# Ordinance No. 240569

## Rezoning to MPD

Stonecroft MPD  
4900 Raytown Road

Neighborhood Planning and Development

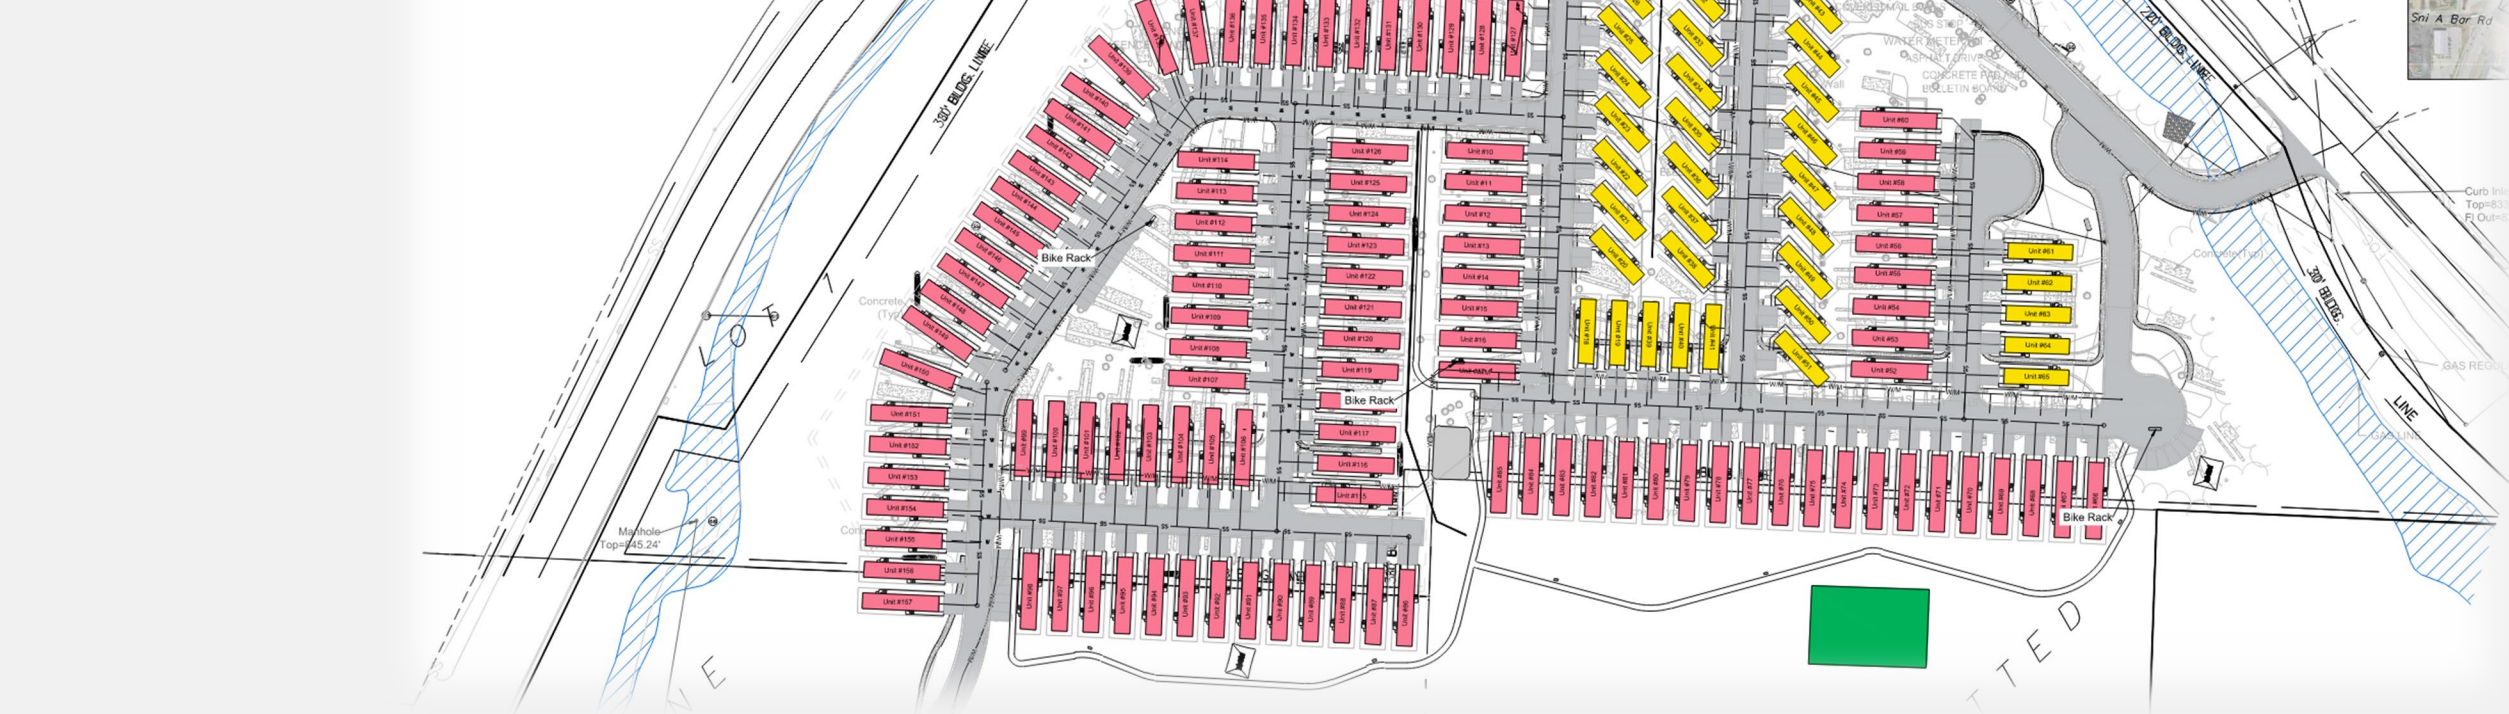
**Revisions are sent to staff to address side setbacks – April 25, 2024**

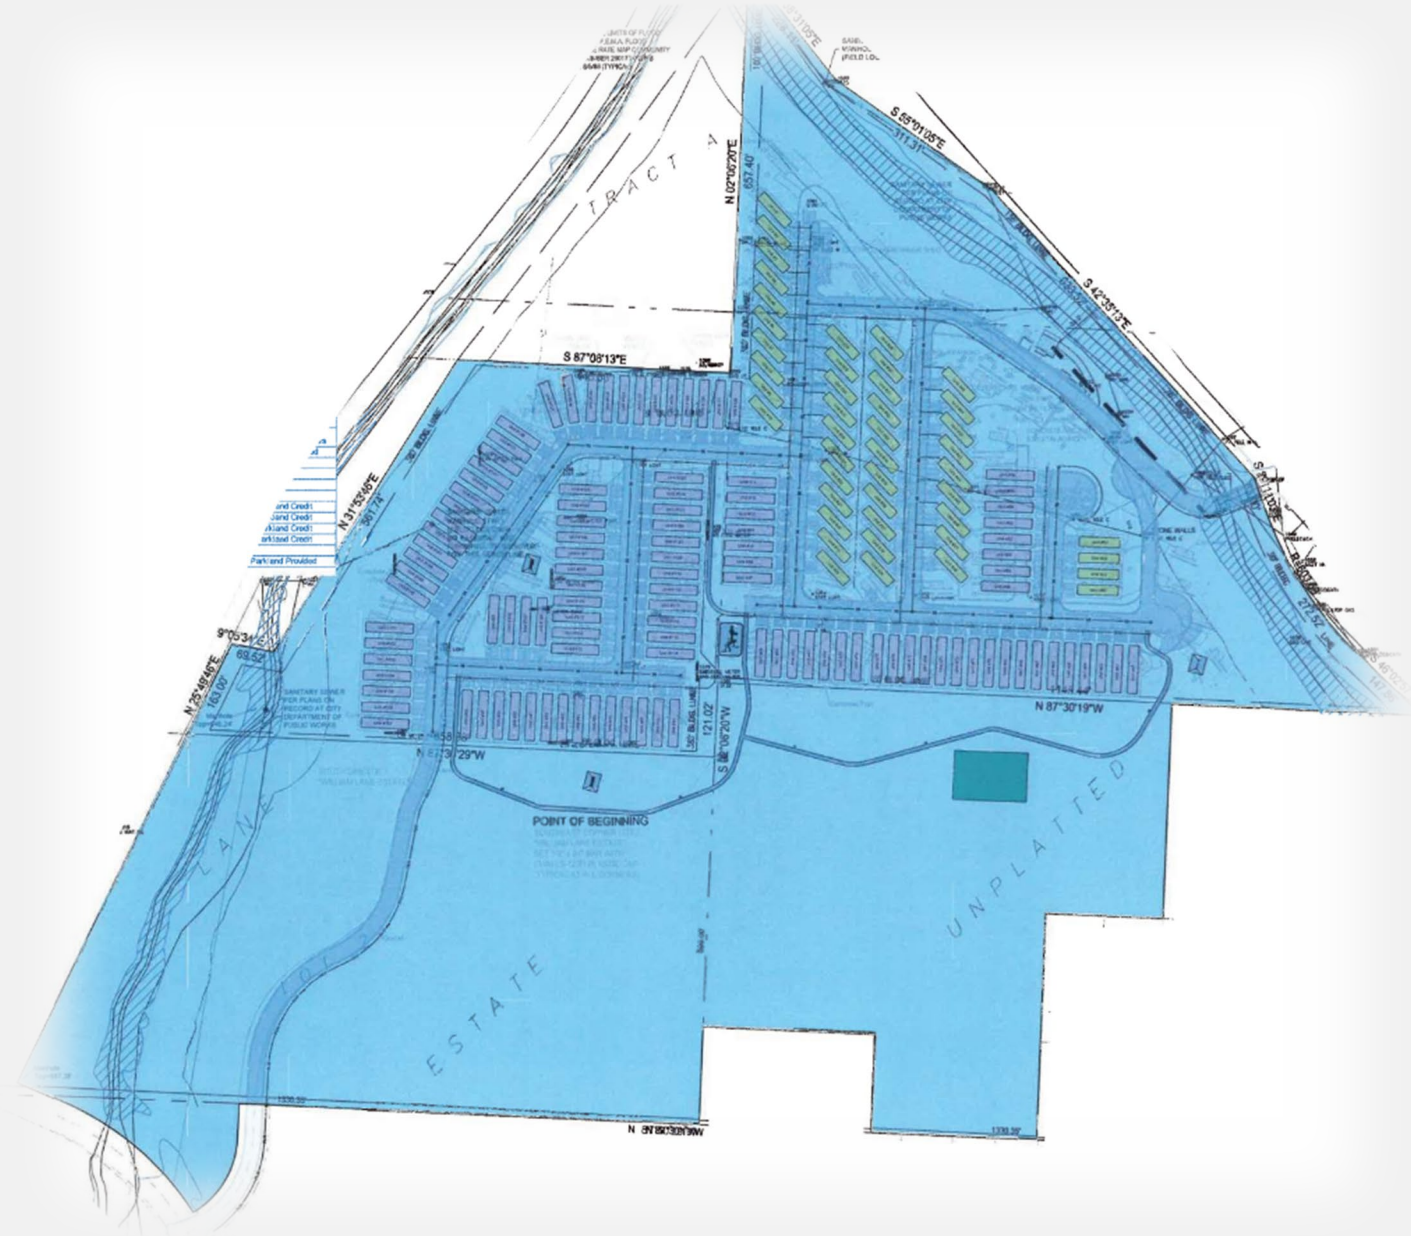
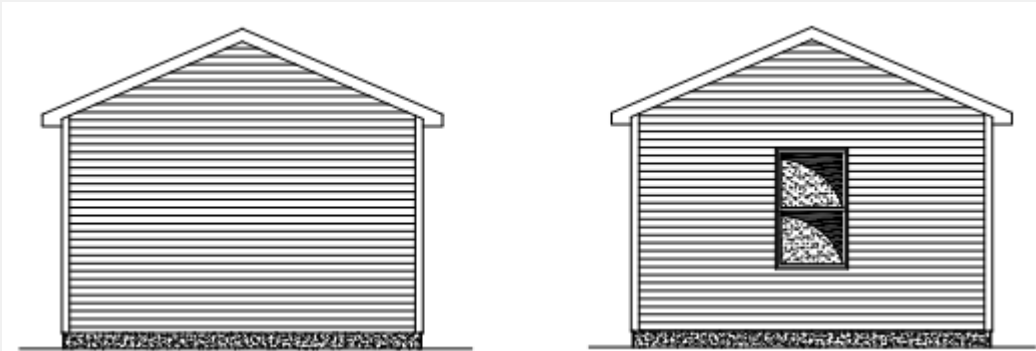
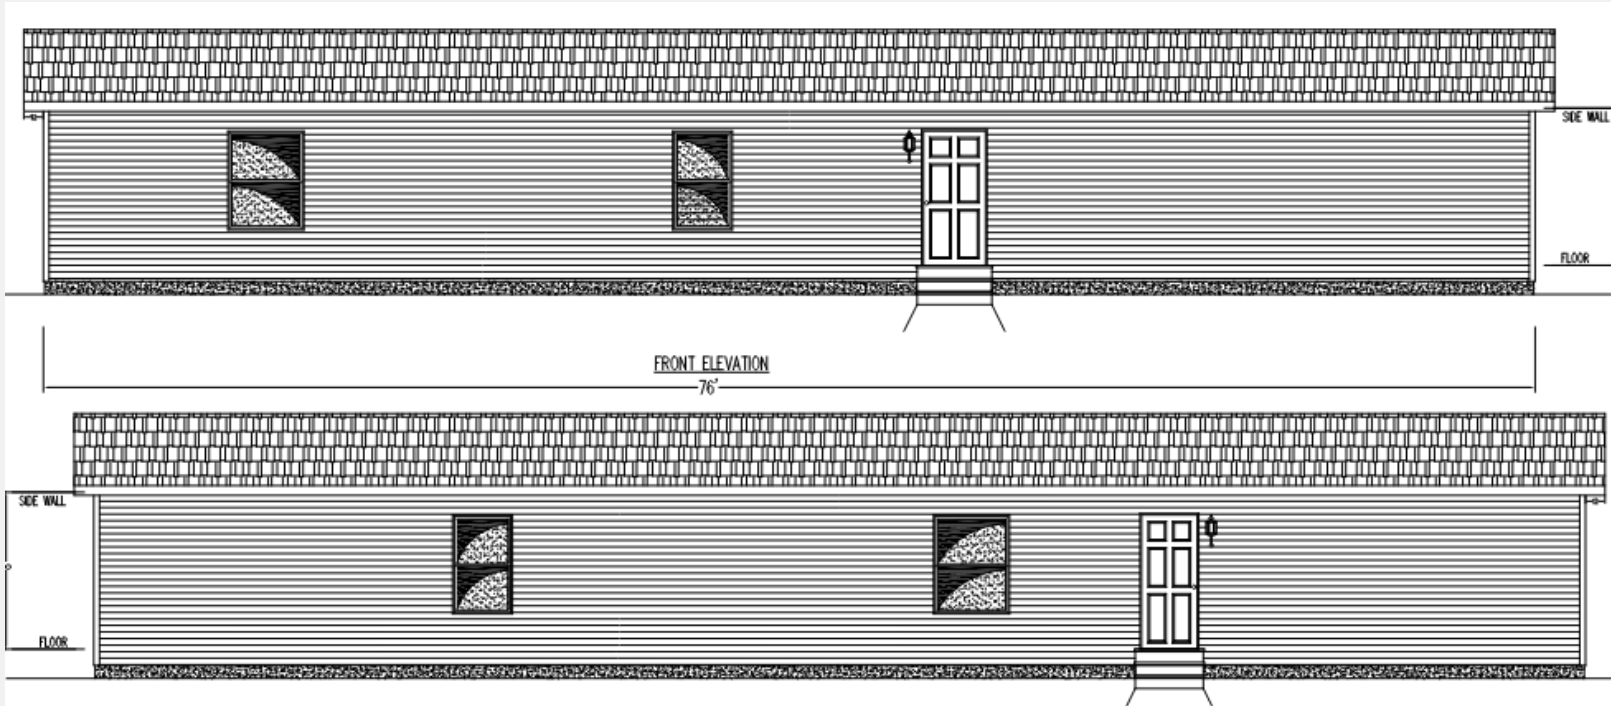
- ~ 50 acres (total site in blue)
- 157 “for sale” units
- 350 parking spaces
- Little to no private space  
→ standard depth for backyard is ~ 25'
- Front yard is only a parking area  
→ exceeds 40% of paved area allowed in front yard (base zoning)

**Elevations**

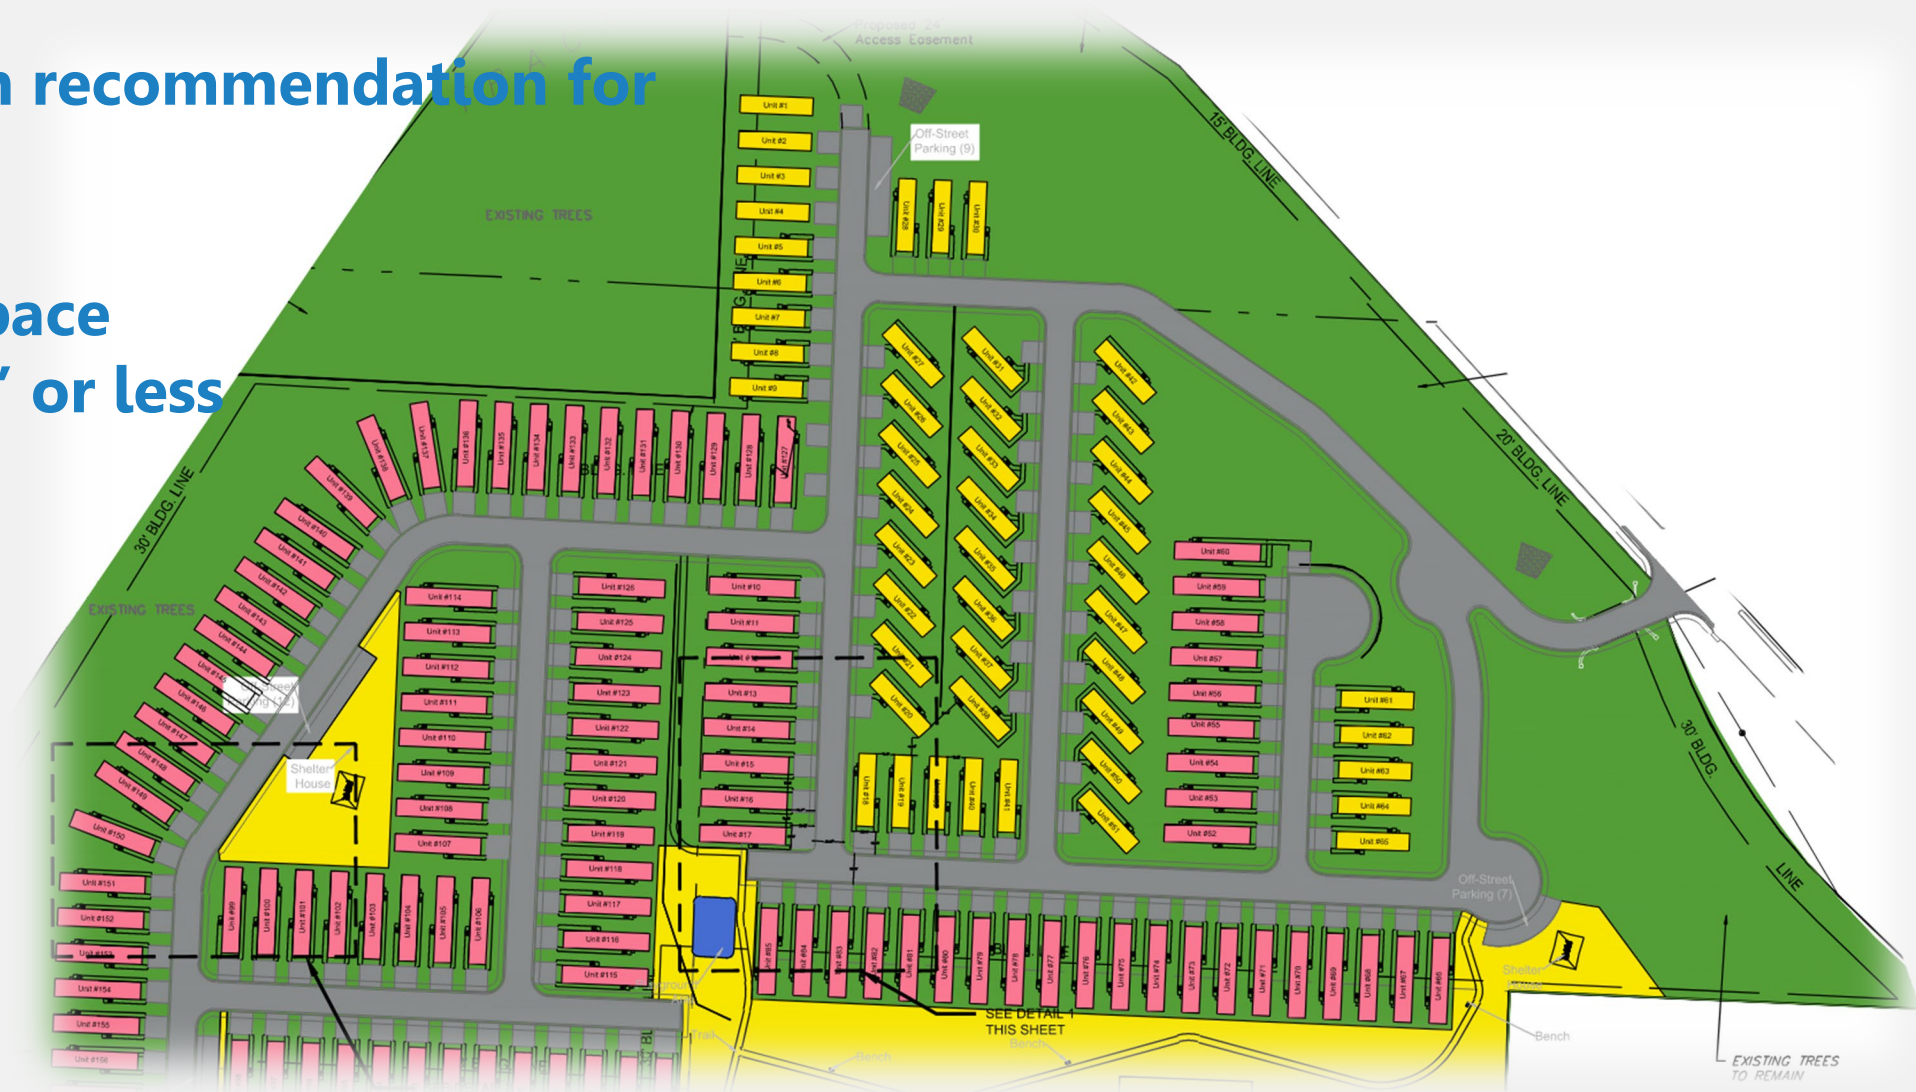
- Proposed Density = 8.8 units p/acre
- Exceeds area plan recommendation for setbacks
- Lack of private space  
→ backyard only 5' or less
